Proposal for the 1 series of amendments to UN Regulation No. 153 (Fuel system integrity and electric power train safety at rear-end collision)

Submitted by the expert from France

The text reproduced below was prepared by the expert from France. The proposal aims to update the requirements on post-crash electrical safety of UN Regulation No. 153. The modifications to the current text of the UN Regulation are marked in bold for new or strikethrough for deleted characters.

Model A
(See paragraph 4.4. of this Regulation)

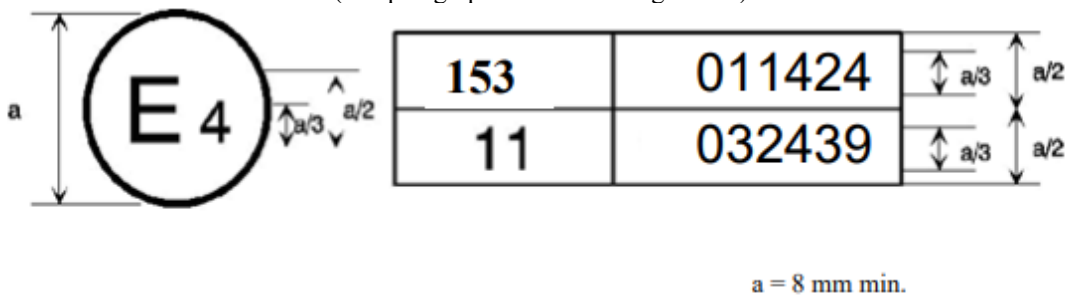
The above approval mark affixed to a vehicle shows that the vehicle type concerned has, with regard to the protection of the occupants in the event of a frontal collision, been approved in the Netherlands (E 4) pursuant to UN Regulation No. 153 under approval number 001424. The approval number indicates that the approval was granted in accordance with the requirements of UN Regulation No. 153 **as amended by the 01 series of amendments**.

Figure 3
Jointed Test Finger

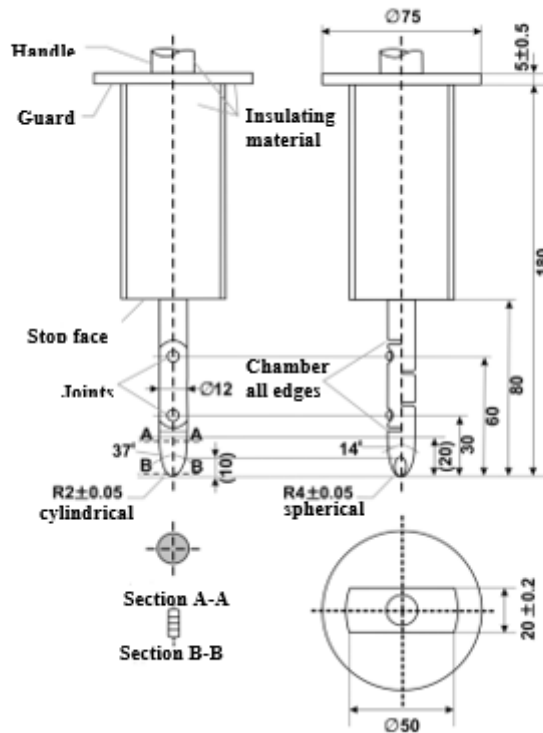
Following the vehicle impact test any parts surrounding the high voltage components shall be, without the use of tools, opened, disassembled or removed. All remaining surrounding parts shall be considered part of the physical protection. The jointed test finger described in Figure 3 shall be inserted into any gaps or openings of the physical protection with a test force of $10\text{ N} \pm 10\text{ per cent}$ for electrical safety assessment. If partial or full penetration into the physical protection by the jointed test finger occurs, the jointed test finger shall be placed in every position as specified below. Starting from the straight position, both joints of the test finger shall be rotated progressively through an angle of up to 90° **degree** with respect to the axis of the adjoining section of the finger and shall be placed in every possible position. Internal electrical protection barriers are considered part of the enclosure. If appropriate a low-voltage supply (of not less than 40 V and not more than 50 V) in series with a suitable lamp should be connected, between the jointed test finger and high voltage live parts inside the electrical protection barrier or enclosure.

Both joints shall permit movement in the same plane and the same direction through an angle of 90° with a 0 to $+10^{\circ}$ tolerance.

The requirements of paragraph 5.2.2.1.3. of this Regulation are met if the jointed test finger described in Figure 3, is unable to contact high voltage live parts.

If necessary, a mirror or a fiberscope may be used **in order** to inspect whether the jointed test finger touches the high voltage buses.

If this requirement is verified by a signal circuit between the jointed test finger and high voltage live parts, the lamp shall not light.

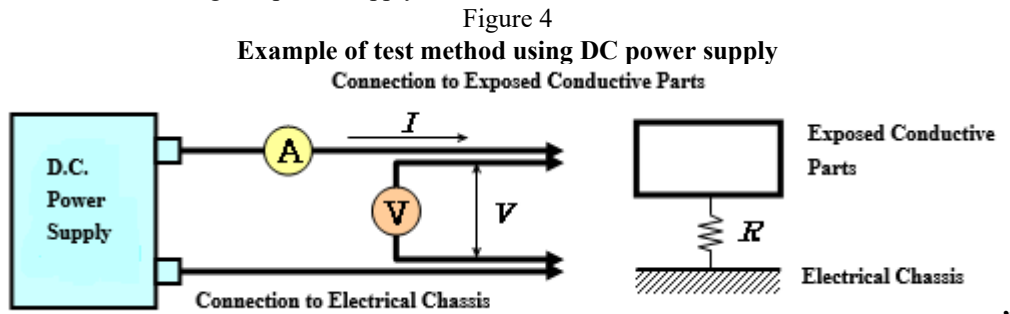
(b) Test method using DC power supply, voltmeter and ammeter.

The DC power supply, voltmeter and ammeter are connected to the measuring points (Typically, electrical chassis and electro conductive enclosure/electrical protection barrier).

The voltage of the DC power supply is adjusted so that the current flow becomes at least 0.2 A.

The current "I" and the voltage "U" are measured.

Note: If lead wires are used for voltage and current measurement, each lead wire shall be independently connected to the electrical protection barrier/enclosure/electrical chassis. Terminal can be common for voltage measurement and current measurement.
